POWER PLANT - NACELLE - POWERPLANT - GEARBOX BREATHER OUTLET DUCT SEAL - REPLACEMENT OF
- CATEGORY CODE 4 - MOD.NAC-71-0075

V2500-NAC-71-0075

SERVICE BULLETIN

REPLACEMENT OF GEARBOX BREATHER OUTLET DUCT SEAL
Fig.1

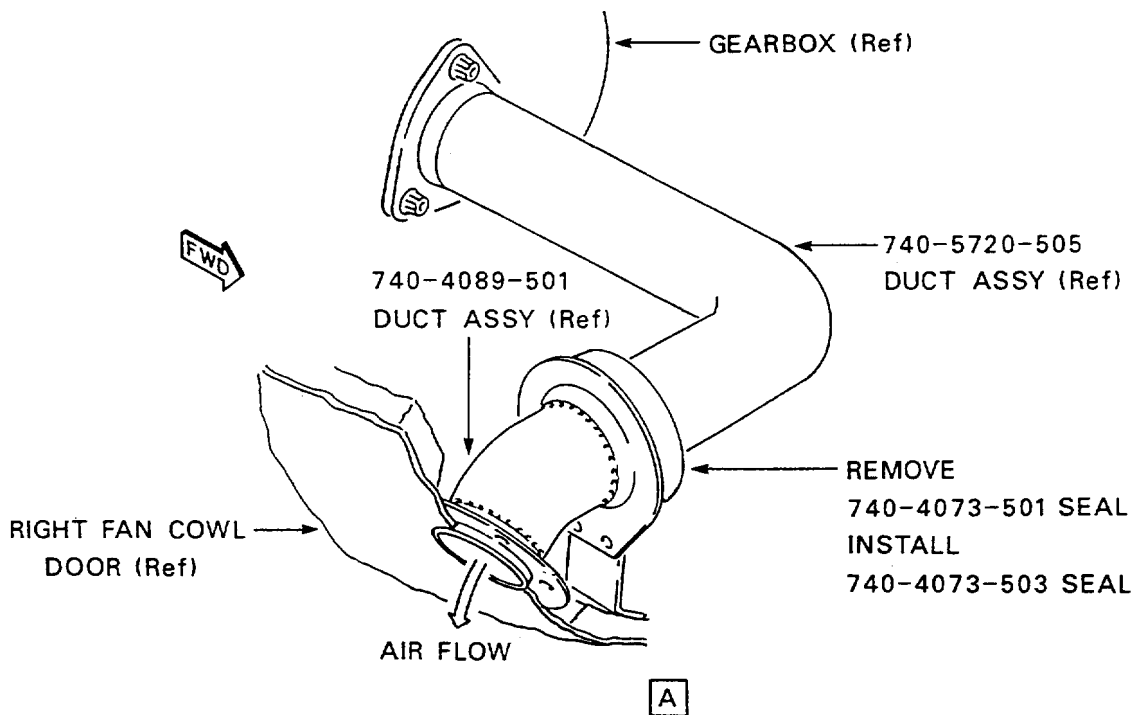
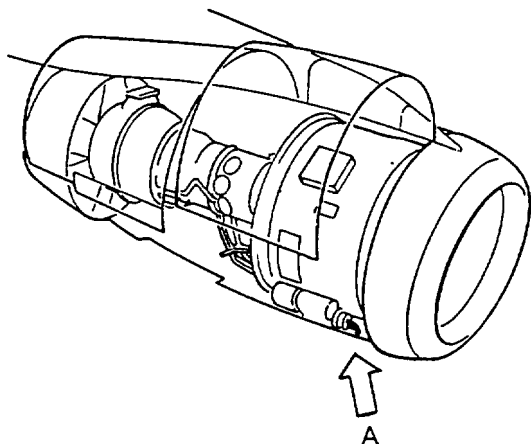
- (1) Locate the 740-4073-501 seal on the 740-5720-505 duct assembly at the engine gearbox. (Refer to figure 1). Remove and discard the seal.
- (2) Install the 740-4073-503 seal on the 740-5720-505 duct assembly.

- (a) The silicone seal on the gearbox breather outlet duct is removed and replaced by a perforated seal.
